AEOD TECHNICAL REVIEW REPORT*

TR REPORT NO.: AEOD/T503

DATE: May 2, 1985

SUBJECT: PRESSURIZER LEVEL INSTRUMENTATION OF COMBUSTION - ENGINEERING
REACTOR UNITS

FIGURE - 1

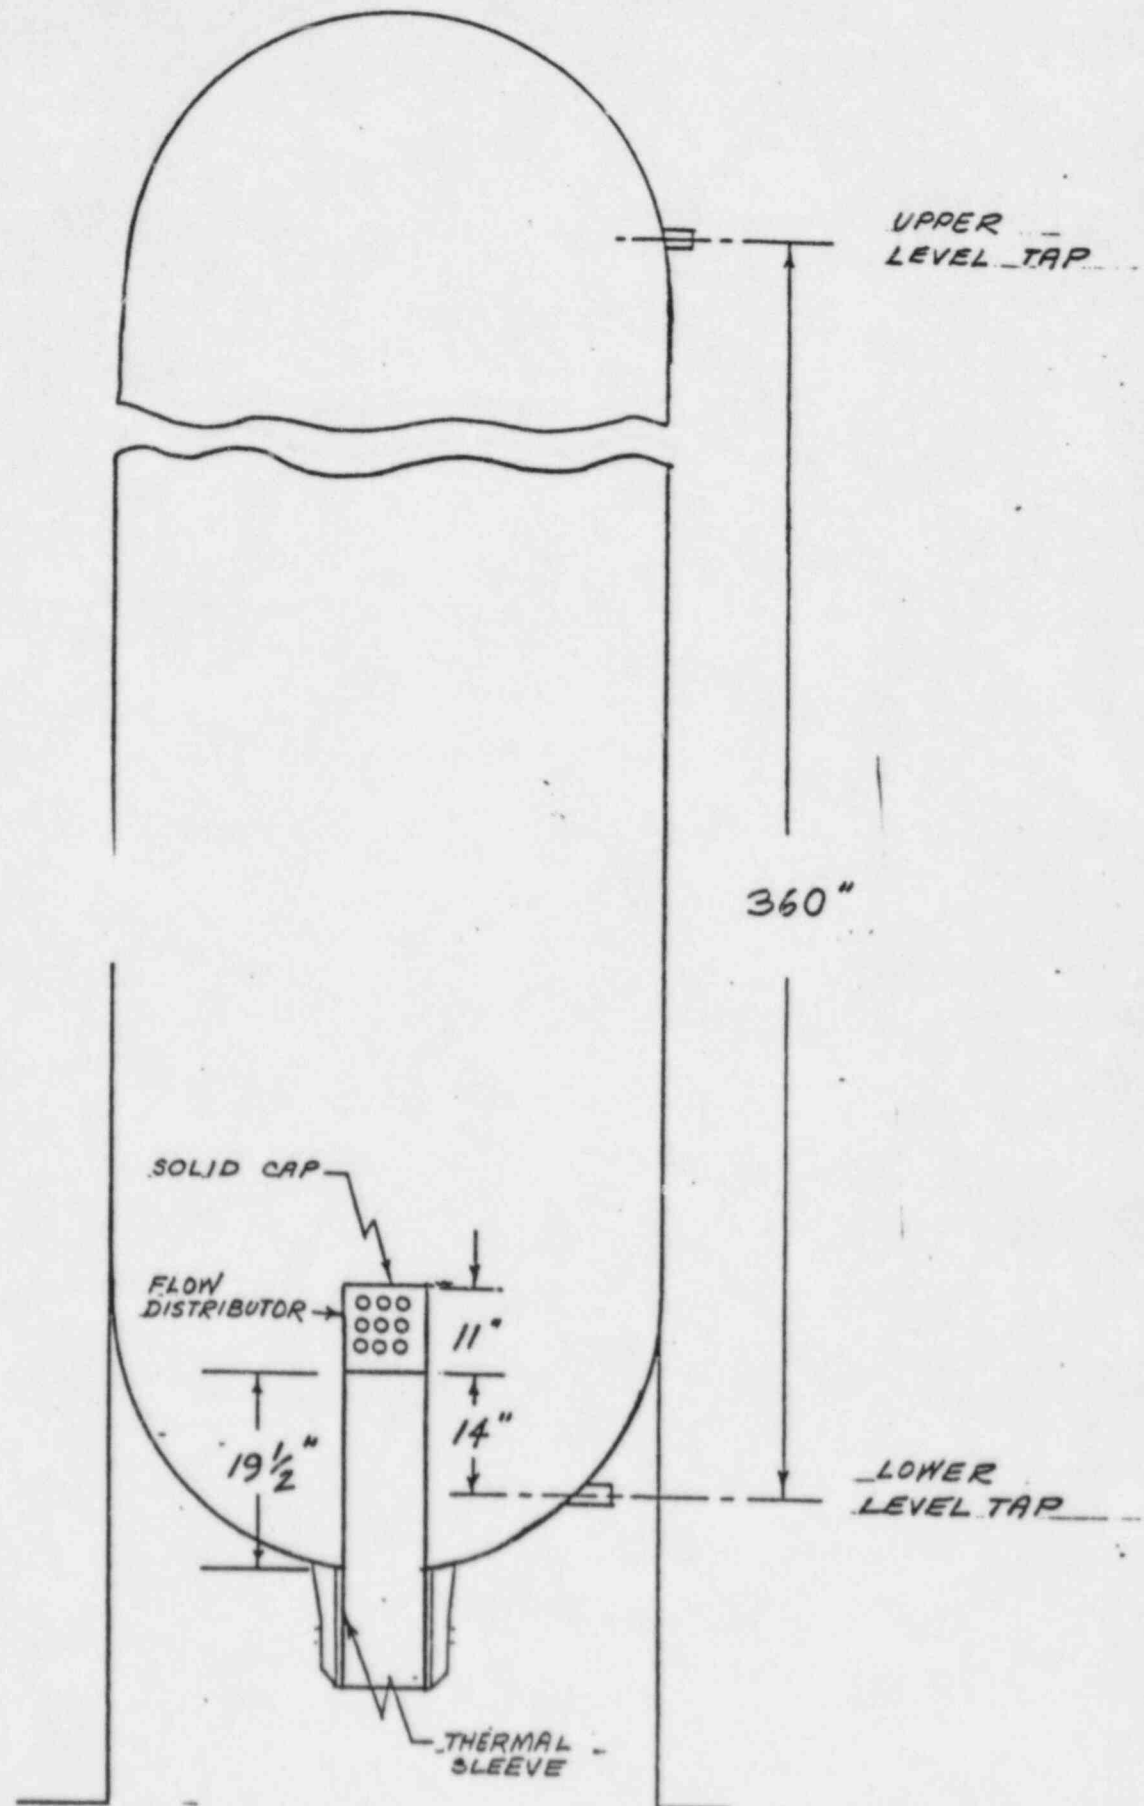
During a review of an overcooling transient at Calvert Cliffs 2, the reviewer identified that the lower level taps of the unit's pressurizer level instrumentation lines were located 14 inches below the surge line inlet (see referenced memorandum). It was postulated that this configuration could lead to the level instrumentation indicating some level when the pressurizer is empty.

The referenced memorandum showed that on the Calvert Cliffs pressurizer, the pressurizer lower level tap is located 14" below the surge line thermal sleeve outlet (see Figure 1). This configuration could imply that with the pressurizer empty, the level indication would show approximately 14". A review of FSAR drawings of some Westinghouse and B&W plants showed that this configuration did not apply to the level instrumentation on the pressurizer for these vendors. A review of the FSAR drawings of all C-E units showed that their pressurizer was the same as the pressurizer of the Calvert Cliffs units. Hence, it was assumed that the configuration of the level instrumentation was also the same.

FIGURE - 2

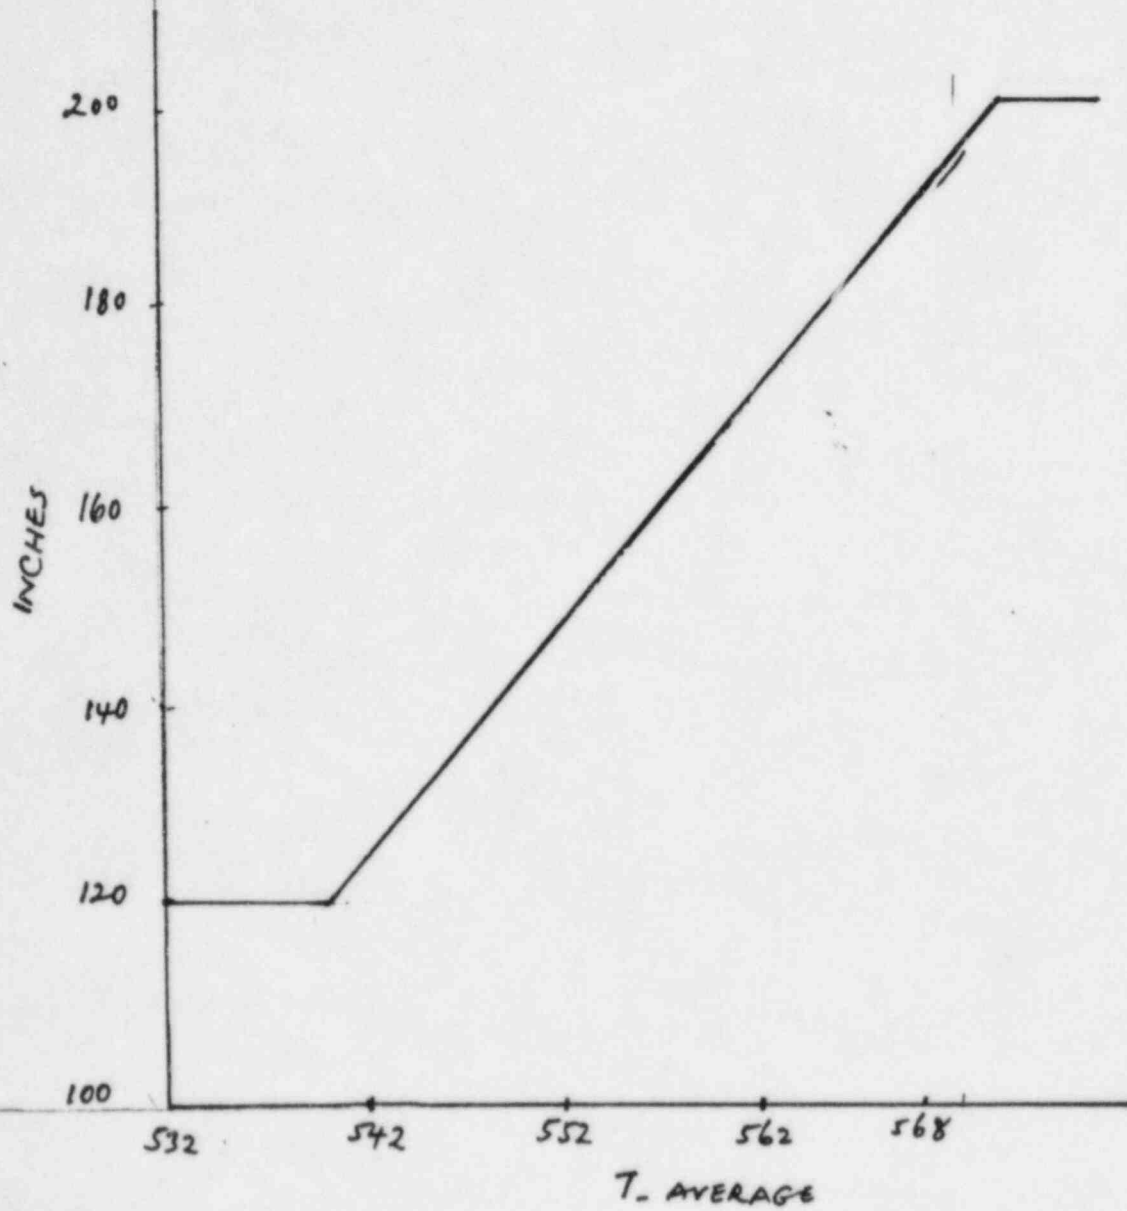
The pressurizer level set point is a function of T average and is typically programmed to increase from 120 inches at 538 F to 200 inches at 568 F (see Figure 2). The programmed level set point will control charging and letdown flow to keep the pressurizer level at the set point level.

FIGURE 3

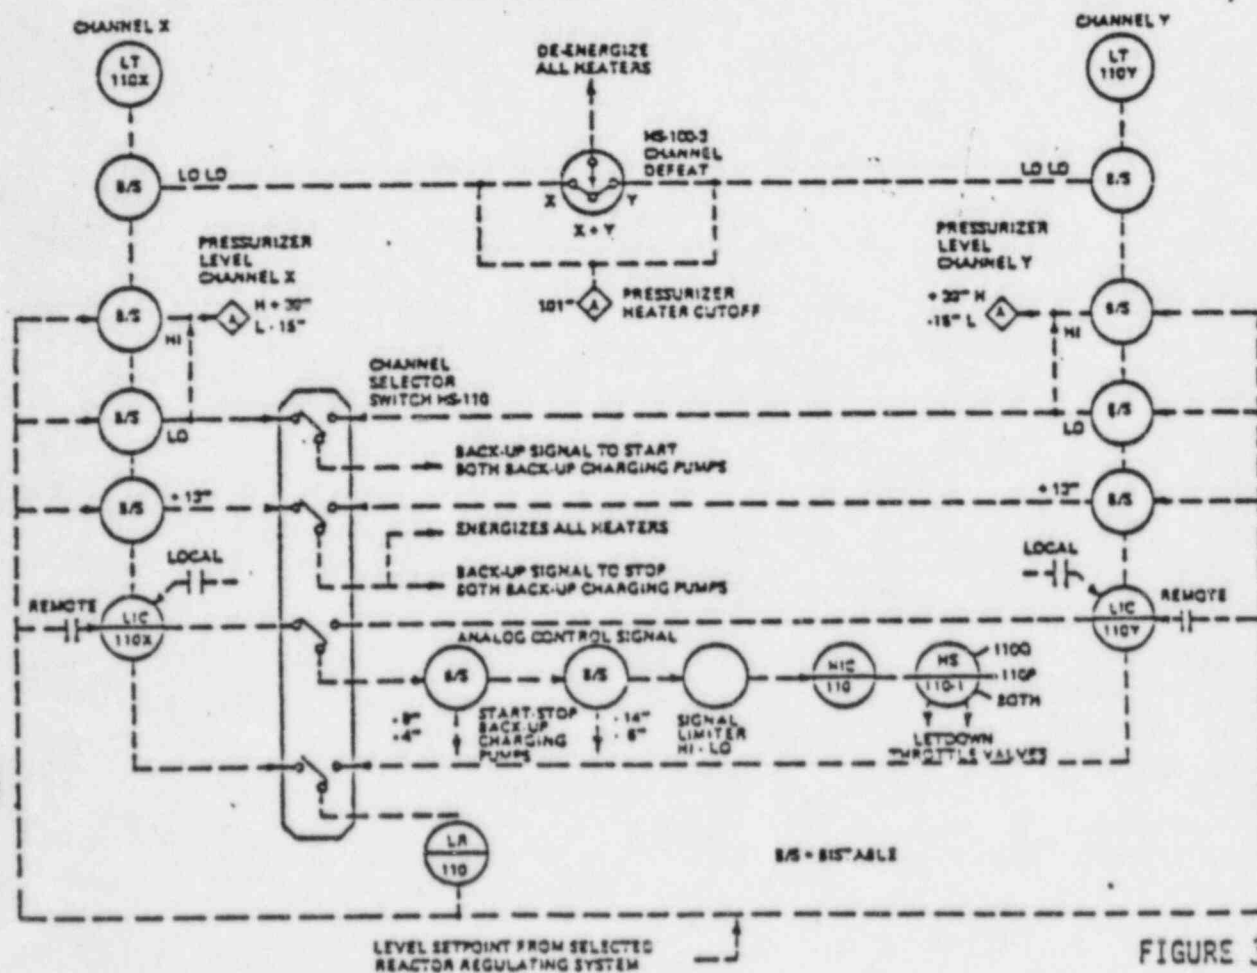
Two separate level channels are provided for control of pressurizer level. Each channel has four bistables and a level indicator controller (LIC). A channel selector switch determines which channel bistable and controller outputs are used for the various functions. Level indication for each channel is provided on the LIC and level from the selected channel is recorded on a level recorder (LR) - See Figure 3.

FIGURE 4

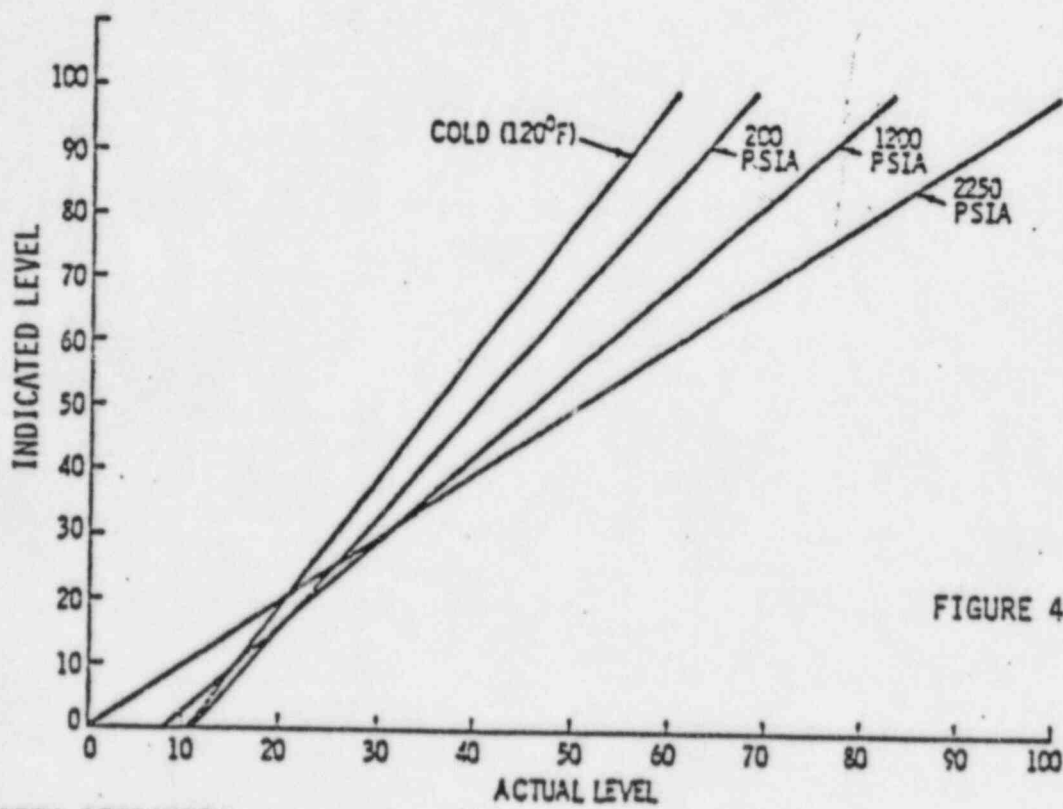
Another item that could be considered is the calibration of the level transmitters. The pressurizer level signal is generated by a differential pressure transmitter that measures the differential pressure between a reference leg (high pressure side of the dp cell) and a variable leg (low pressure side). The dp instrument is usually calibrated for full power conditions (2250 psia). For pressures other than normal full power pressure in the pressurizer, the actual level and indicated level will differ as shown in Figure 4. This figure shows that for pressure lower than normal operating pressure at the lower end of the level scale the indicated level will read lower than the actual level. Since the pressurizer heaters are cut-off at 110 inches level, the pressurizer pressure will be lower than normal full power pressure for levels below this point. This is the reason why C-E plant operators have been cautioned about the level indication at the lower range.
